# 1959 Corvette: Service Bulletin: Windshield Washers

**SUBJECT:** 1959 PASSENGER CAR  
WINDSHIELD WASHERS

**BULLETIN No.** DR #405

**FIG. #1**

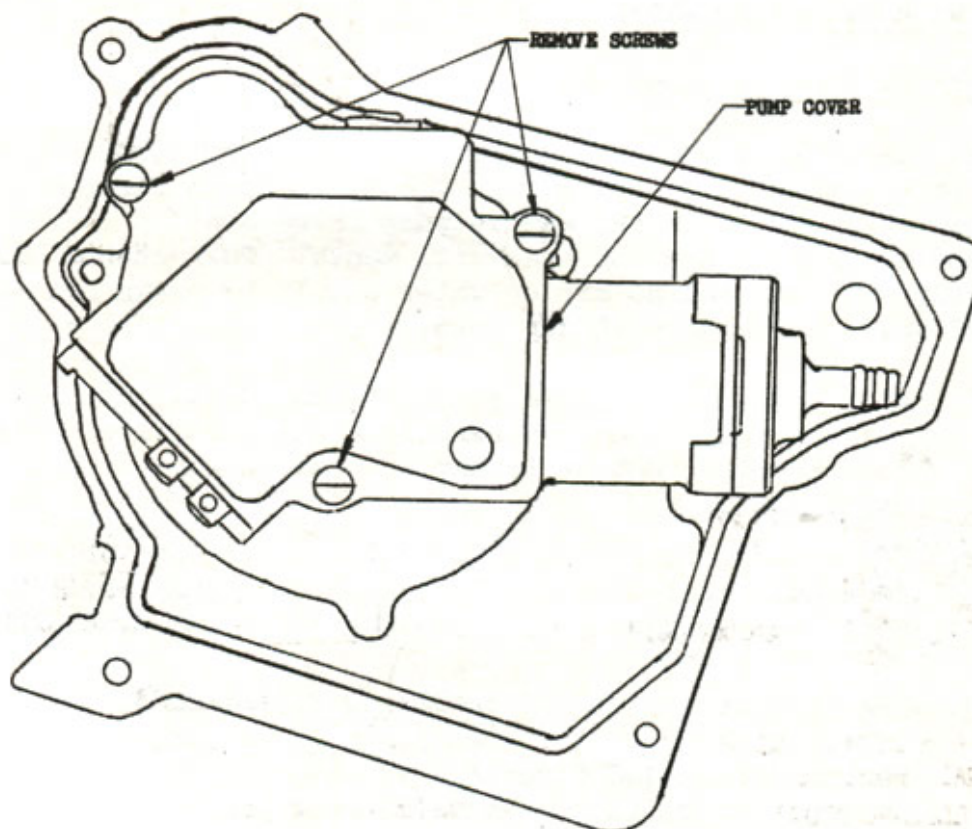
1. Remove pump cover. Cover is retained by three (3) screws. See Figure #1.
2. Lift terminal board up.
3. Pull relay out of pump body. Relay is retained by clip. Relay, armature and terminal board will come out together. See Figure #2.
4. Reinstall new Relay and Terminal Board Assembly, #4906055.

**CORRECTION:** Replace Relay and Terminal Board Assembly, #4906055 (late type armature is part of this assembly).

ARMATURE - LATE DESIGN  
FIG. #4

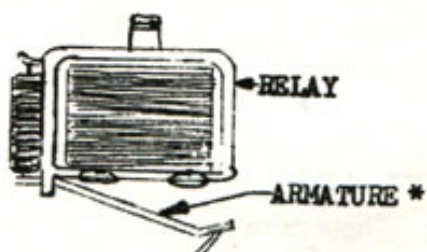
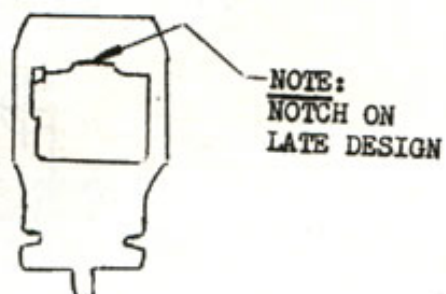
A few very early units may have a relay armature with a small opening or window which may contact the drive pawl. This could allow the drive pawl to push the armature up out of the park position and allow unit to recycle. Later armatures had a wider window and also a notch at end that contacts nylon gear. This notch prevented the drive pawl from catching top of ratchet tooth which also may cause unit to recycle. Later armatures incorporated additional features to maintain free movement and assume proper stop.

NOTE: See Figure #4, examples of early and late armature.

FIG. #6

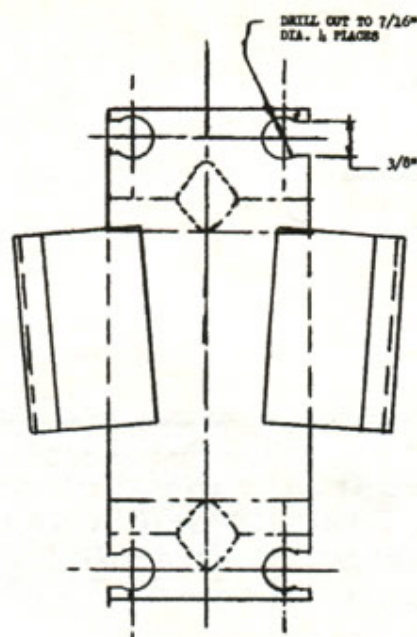
2. Drill out the four attaching holes in washer mounting bracket to 7/16". Cut away out board edge of attaching holes so grommet can be pressed into bracket. See Figure #6.

FIG. #7

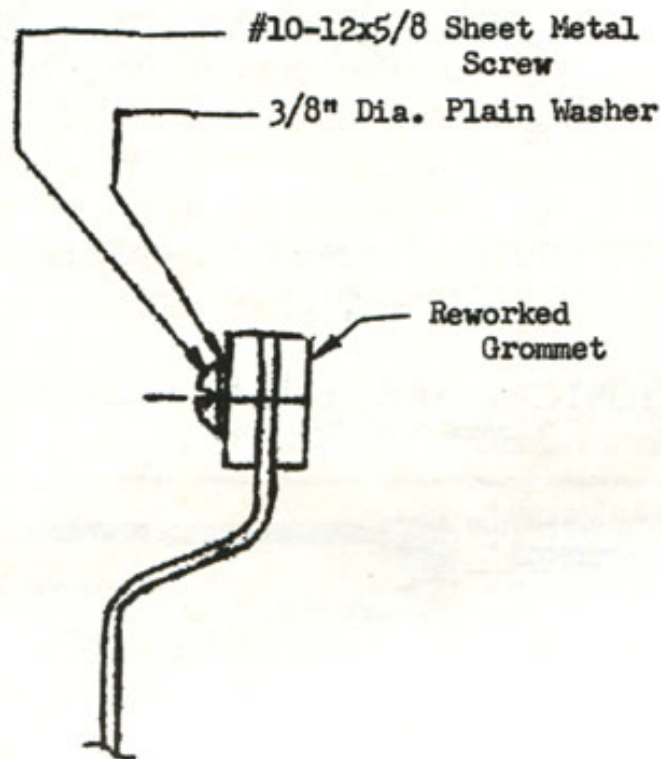
3. Place  $\frac{3}{8}$  diameter flat washers on front side of reworked grommets and attach bracket to dash. See Figure #7.
